From: Kiefer, Sharon [sharon.kiefer@idfg.idaho.gov]
Sent: Wednesday, April 14, 2010 6:38 PM
To: Lemont, Stephen; bmbiwer@anl.gov
Cc: Hebdon, Lance; Vecellio, Gary
Subject: IDFG Response to NRC AREVA Supplemental Request
Attachments: E-mail from NRC to Sharon Kiefer regarding additional AREVA project information 2-10-2010.txt; Response to NRC AREVA transmission supplemental request Mar 2010.docx

The Idaho Department of Fish and Game (Department) is providing this information in response to a February 10, 2010 request by Stephen Lamont of the Nuclear Regulatory Commission (NRC) to Sharon Kiefer. These items are provided in supplement to the responses provided by the Department on August 4, 2009. This response incorporates potential issues related to a power line to service the infrastructure, which was not identified in 2009.

Figure 1. Location of sensitive species records from the IDFG Natural Heritage database and Sage-grouse habitat in proximity to the proposed AREVA transmission line.

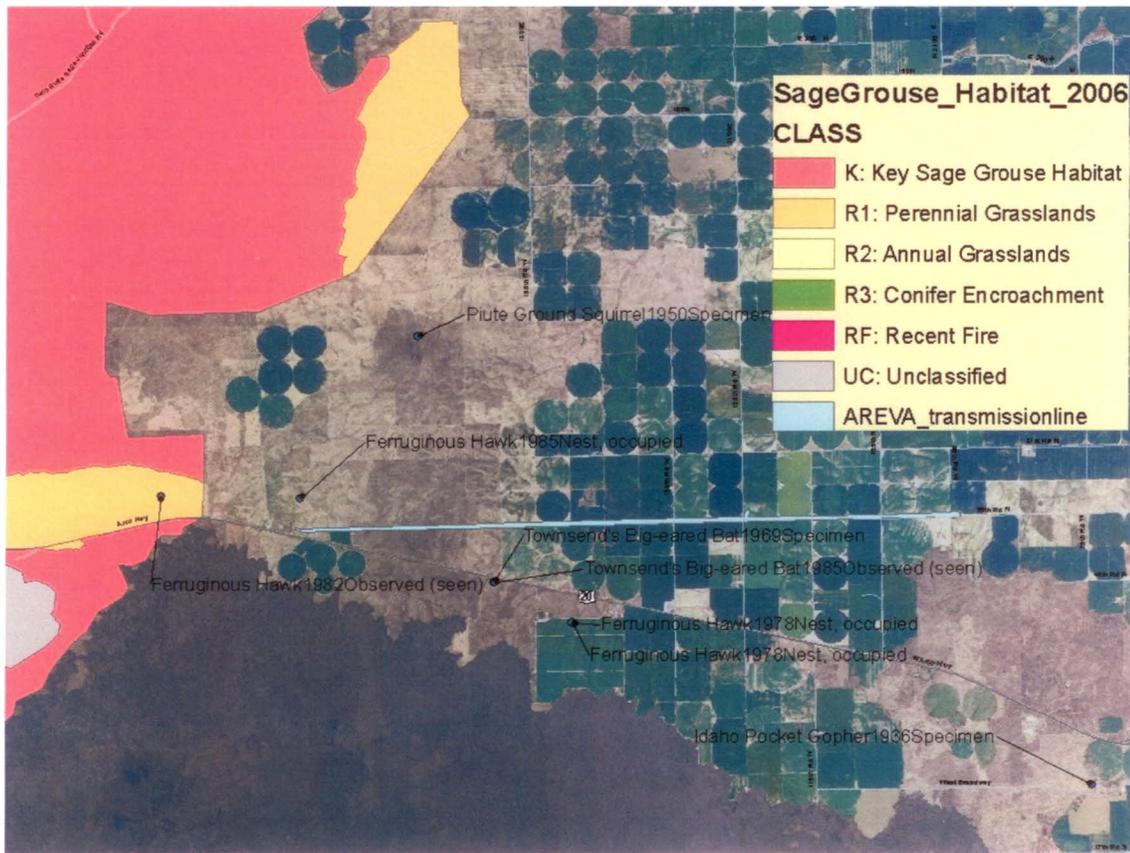
Department staff considers the areas both north and south of your proposed power line to be important habitat for lek development, rearing, and migration of sage grouse. It is likely that a new above-ground transmission line will cause direct mortality of migrating sage grouse due to grouse striking the lines during flight. The locations of sensitive species from the Idaho Natural Heritage Database and occupied sage-grouse habitats in the vicinity of the proposed right-of-way for the power line are depicted in Figure 1. Department staff is unaware of any federally-listed species within the bounds of the project.
